SHEARON HARRIS NUCLEAR POWER PLANT, UNIT NO. 1
DOCKET NO. 50-400/LICENSE NO. NPF-63
RESPONSE TO REQUEST FOR ADDITIONAL INFORMATION REGARDING
SUPPLEMENTAL RESPONSE TO GENERIC LETTER 2004-02, "POTENTIAL IMPACT OF
DEBRIS BLOCKAGE ON EMERGENCY RECIRCULATION DURING DESIGN BASIS
ACCIDENTS AT PRESSURIZED-WATER REACTORS" (TAC NO. MC4688)

SHEARON HARRIS NUCLEAR POWER PLANT, UNIT NO. 1
DOCKET NO. 50-400/LICENSE NO. NPF-63
RESPONSE TO THE REQUEST FOR ADDITIONAL INFORMATION
REGARDING SUPPLEMENTAL RESPONSE TO GENERIC LETTER 2004-02

Figure 13-1: Test #3 Chemical Effects Head Loss & Turbidity vs. Time

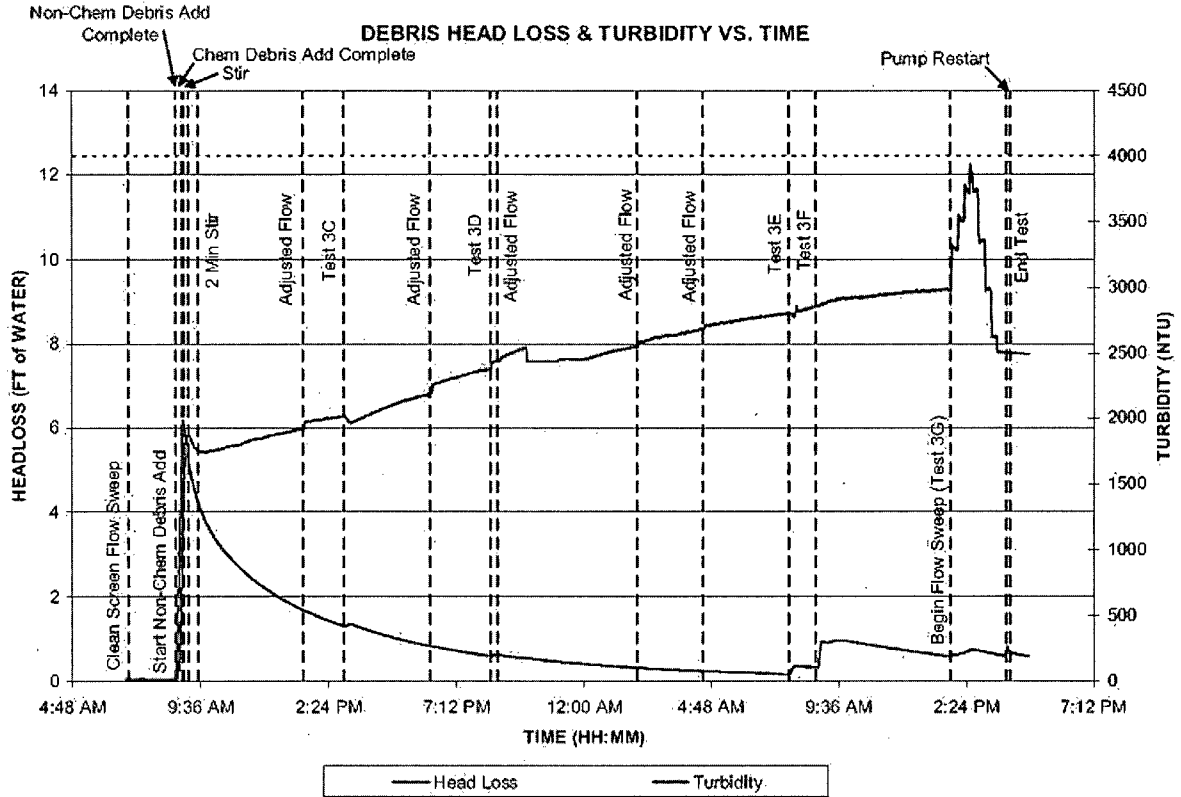
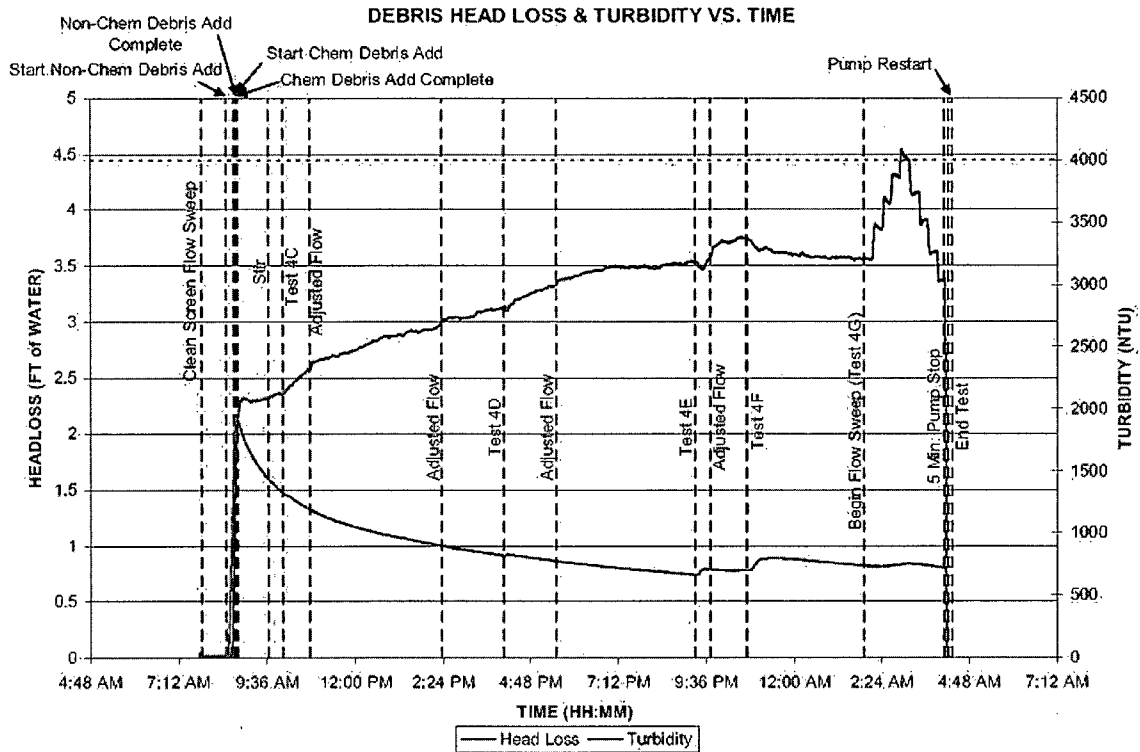
The Min-K specific head loss test that incorporated the bypass eliminator mesh resulted in an unacceptable head loss (9.37 ft) and was considered non-representative of the plant because the bypass eliminator mesh was not installed in the final HNP strainer design. The licensee's supplemental response essentially concludes that the removal of the bypass eliminator mesh is solely responsible for the reduction in head loss (to 3.57 ft) observed in the subsequent head loss test, according to the information provided by the licensee, ultimately demonstrated a very small passing margin of 0.12 ft.

Please provide the basis for (1) attributing the lower head loss associated with the test without bypass eliminators solely to the removal of the mesh and (2) the position that the expected variation associated with a repeat test performed for the HNP strainer design without bypass eliminators could not exceed the small demonstrated margin available for the residual heat removal (RHR) pumps of 0.12 ft.

Test #4 (Min-K test without bypass eliminator mesh) was conducted identically to Test #3 (Min-K test with bypass eliminator mesh). Test #4 was conducted with the exact same debris quantities used for Test #3, and the same test procedures were followed. The purpose of not utilizing the debris bypass eliminator was to determine whether or not there is a significant difference in head loss from a test that utilizes the bypass eliminator mesh and one that does not. Observing the representation of the test data in Figure 13-1 and Figure 13-2, the formation of the debris bed following the addition of the non-chemical debris and the first portion of the chemical precipitates in Test #4 closely matched that which was observed in Test #3. The same initial steep increase, then a slight decrease for a short period, followed by a gradual increase over many hours until the head loss eventually levels off and remains constant, was observed in both tests. The obvious difference between the two tests (Tests #3 and #4) is the resultant head loss. Test #4 results are considerably less (by more than 50 percent) than the Test #3 results. Also, as can be seen from the Figure 13-1 and Figure 13-2, the turbidity level is significantly higher for Test #4. The low turbidity levels for Test #3 indicate a fully covered screen capable of filtering particulate and chemical precipitate debris. The high turbidity levels for Test #4 indicate that there is insufficient fibrous debris to cover the strainer and open area is available for particulate debris to circulate through. The addition of each batch of chemical precipitate does not produce a large increase in head loss with each batch which indicates that there is available open area for precipitate to pass through the screen.

Therefore, the turbidity test data and the post-test debris bed photographs provide evidence that the lower head loss associated with the test without bypass eliminator mesh can be attributed to the removal of this mesh. Additionally, non-chemical effects debris testing using the Microtherm debris mixture was performed twice. The initial test yielded a head loss of 0.39 feet, and the confirmatory test resulted in a head loss of 0.48 feet. The difference between these head loss values is less than 0.1 feet, which indicates that test procedures and practices produce satisfactory repeatability of results. Because Min-K is fabricated from the same constituents as Microtherm and because the same test procedures and practices were employed, it is expected that Min-K testing would also yield repeatable results.
